Analysis of Proposed Changes to the Cedar LNG Project

DRAFT REPORT

March 2025

FIGURE 1. CEDAR LNG PROJECT FACILITY AND MARINE TERMINAL AREA, TRANSMISSION LINE CORRIDOR, ALTERNATIVE TRANSMISSION LINE CORRIDOR AND DISTRIBUTION POWERLINE

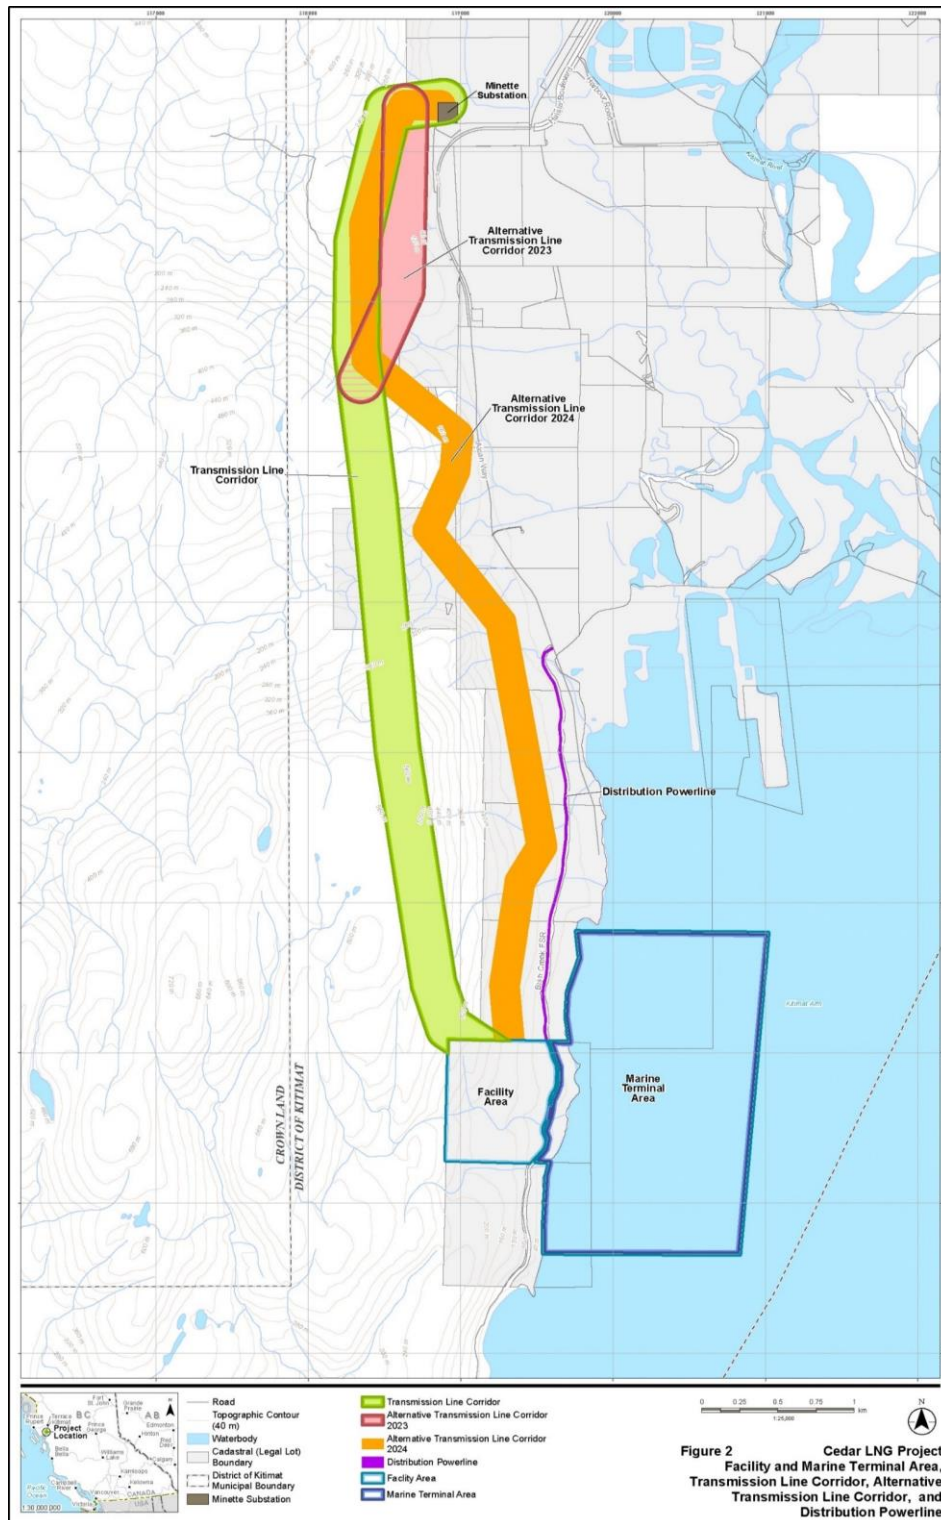
- Add a new 2.8 km long, 25 kilovolts (kV) Distribution Powerline, along the Bish Creek Forest Service Road (FSR) to the Marine Terminal Area.
- Add an alternative 8.5 km long 287 kV transmission line route option between the Minette BC Hydro Substation and the Marine Terminal Area (identified as the Transmission Line Corridor 2024 on Figure 1 below):

- relocated downslope toward Douglas Channel (a shift from Crown to private land);
 - with an increased right of way from 45 m to 90 m to accommodate safety and operability requirements;

- that results in increased clearing from 32.5 ha to 69 ha; and
 - with a reduced width of permitting corridor from 300 m to 200 m.

FIGURE 2. CEDAR LNG PROJECT AMENDMENT

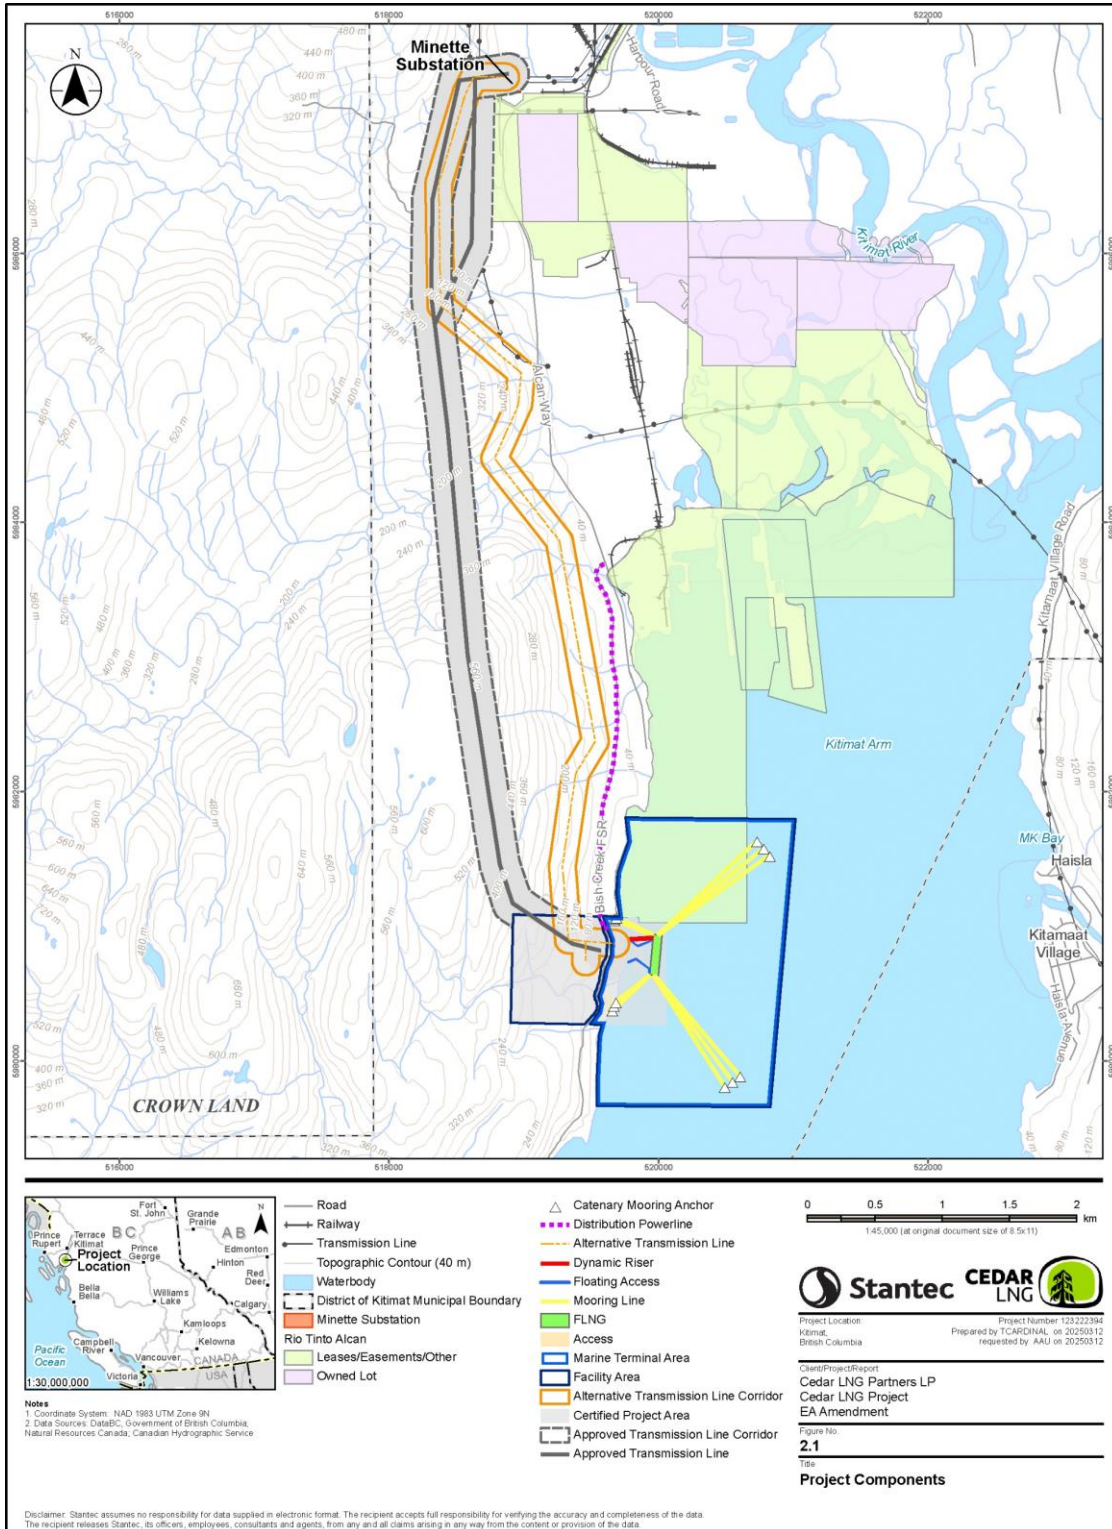
- Expand the Marine Terminal Area from 35.8 ha to 277.3 ha to encompass the mooring lines and anchors for the floating liquefied natural gas (FLNG) facility's catenary mooring system. The increase in hectares (ha) represents the area covered by the submerged mooring lines as shown on Figure 2. The installation of the mooring system will cover approximately 0.09 ha of seabed. No change will occur for the land-based portion of the Facility Area.
